BZA #20382

Parties in Opposition

June 16, 2021

Significant **UNDUE light and noise nuisance** to Wilson and Howell Residences

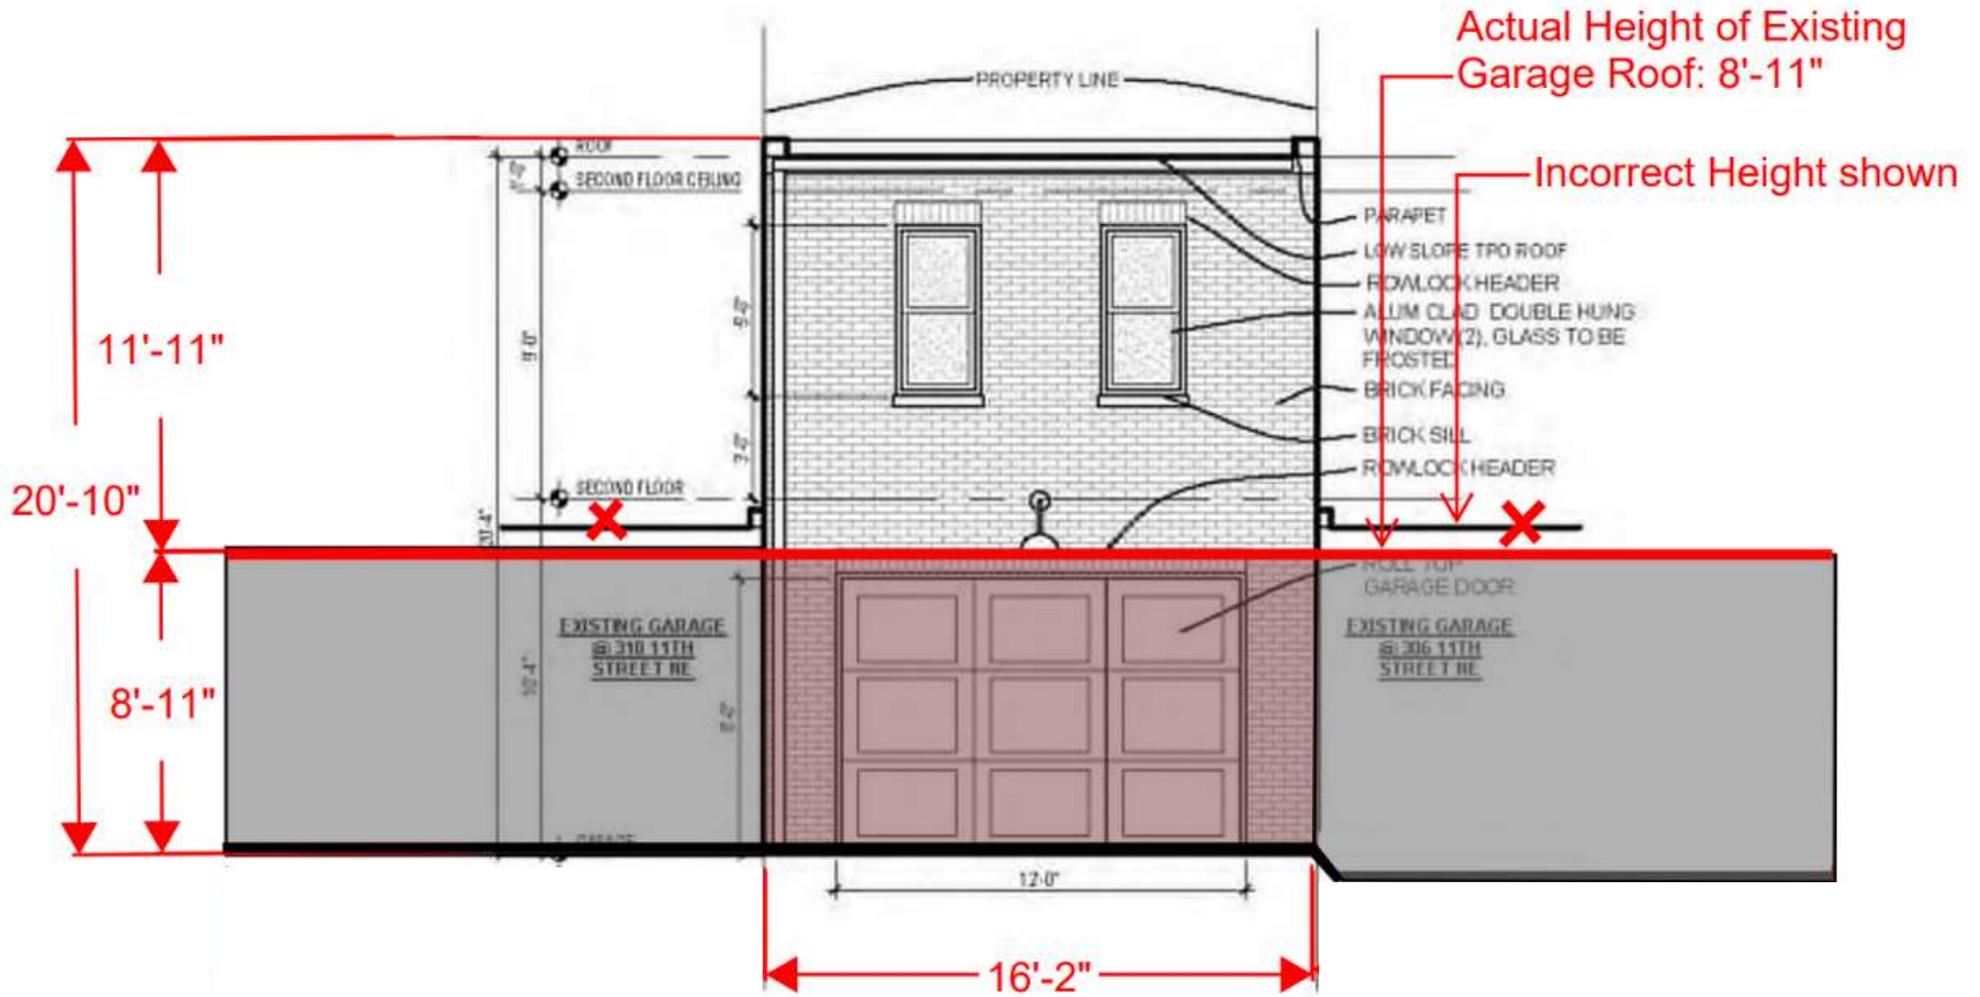
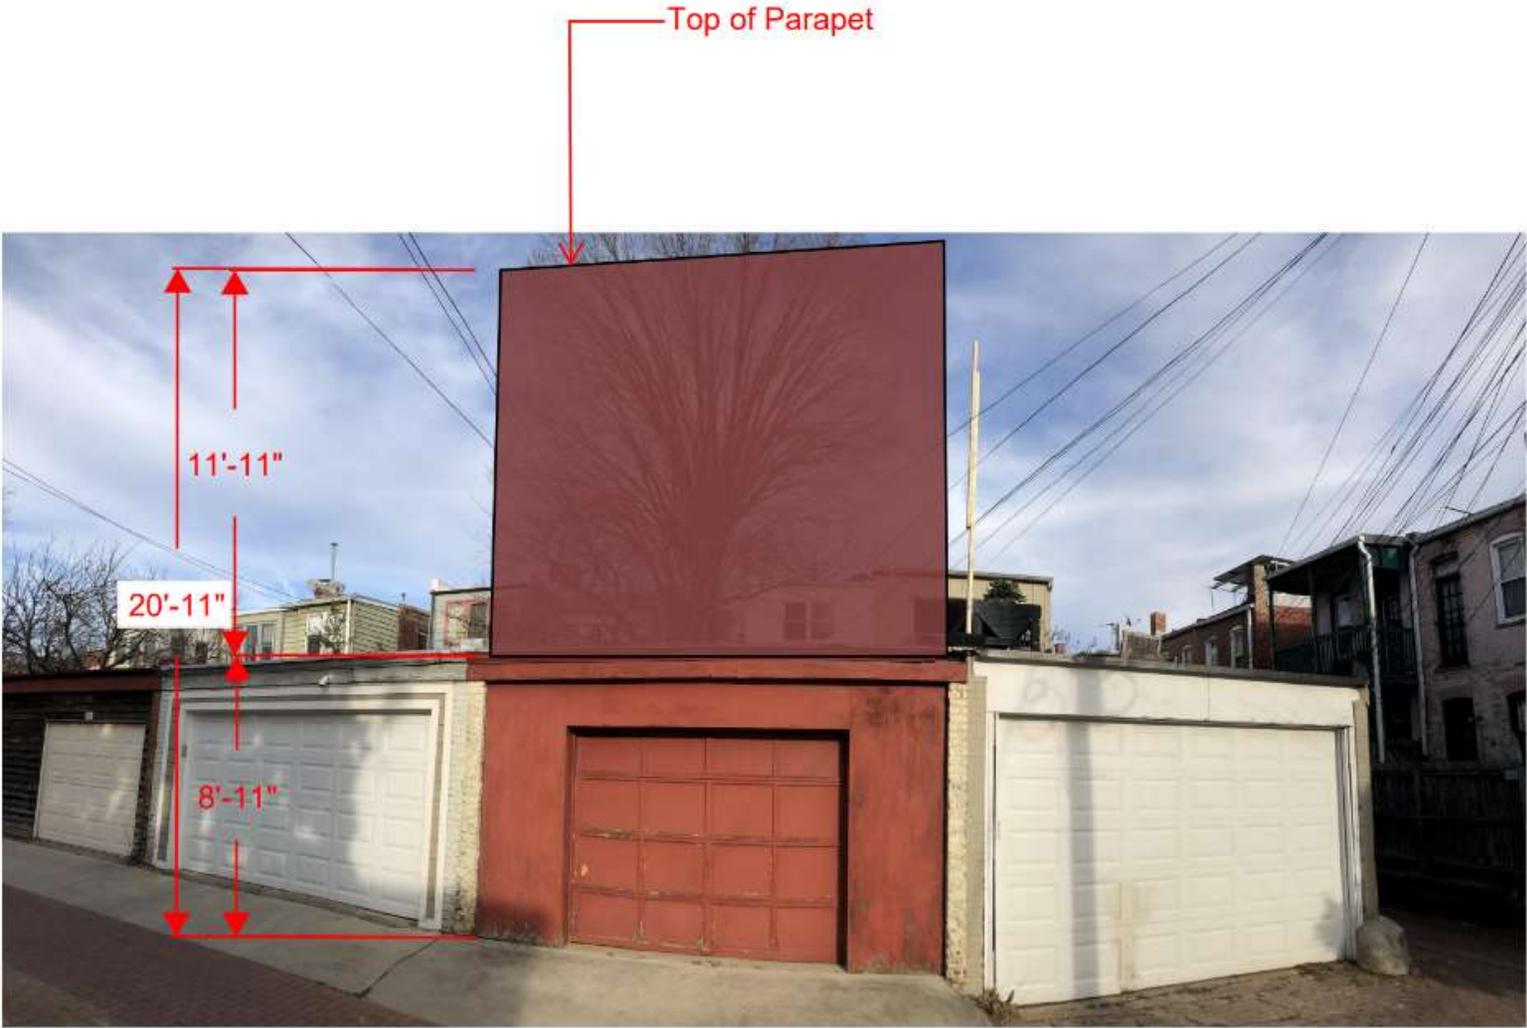
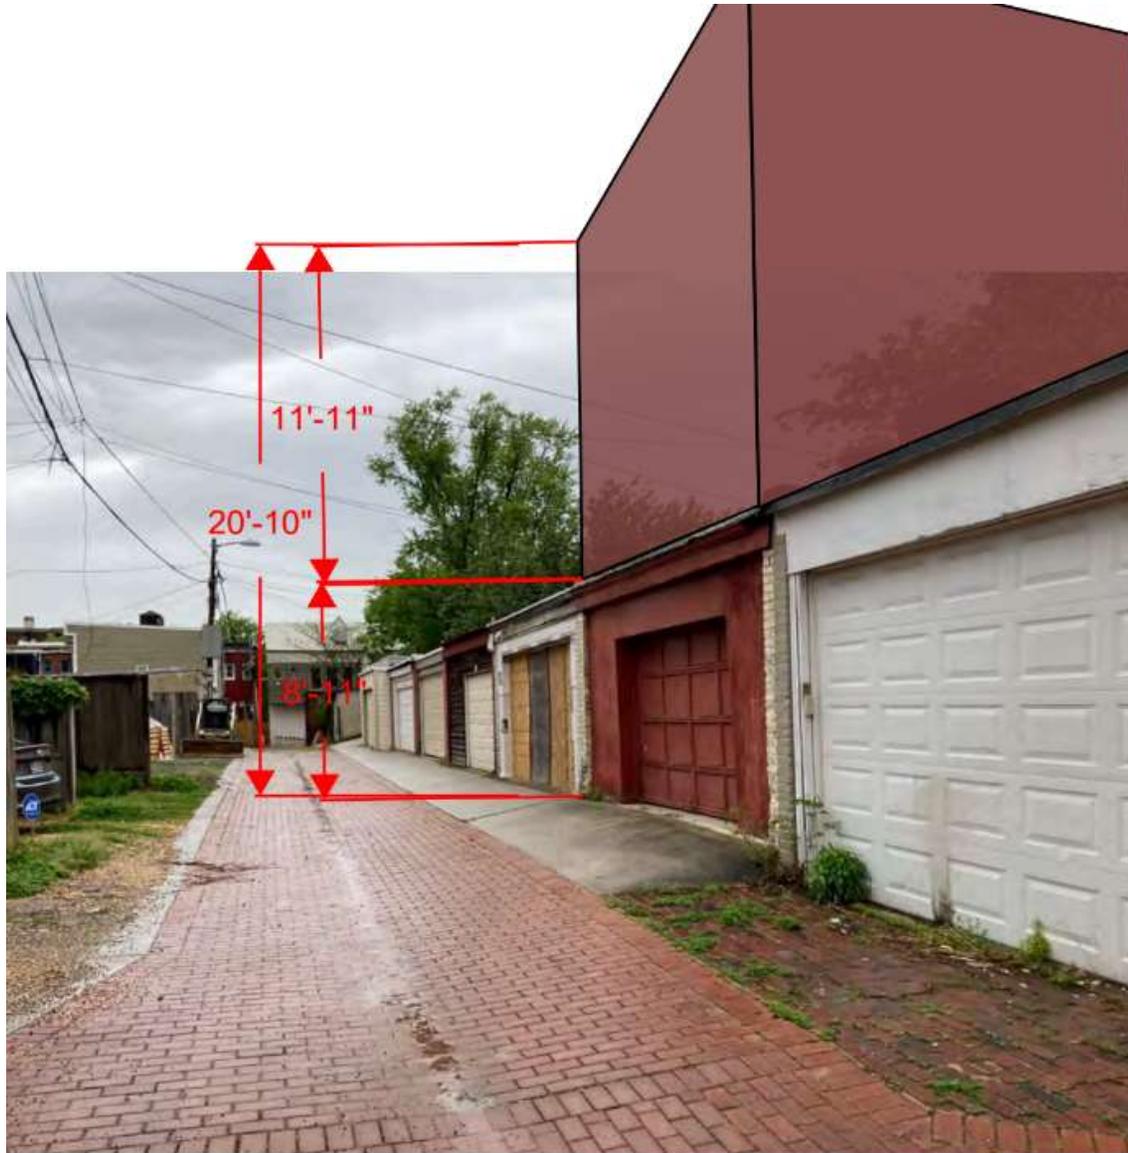
- Significant undue light pollution from unfrosted ADU windows in close proximity to Howell master bedroom.
- Significant undue noise nuisance from rooftop deck that is directly above adjacent to Wilson and Howell family bedrooms.

- **2-level garage with apartment will significantly Visually Intrude Upon the Character, Scale, and Pattern As it Has Existed for More than 100 Years (11-E DCMR 5201.3)**
- 2-level garage/apt will be destroy the unique, nearly uniform span of low-level garages across the entire length of the east side of the alley.
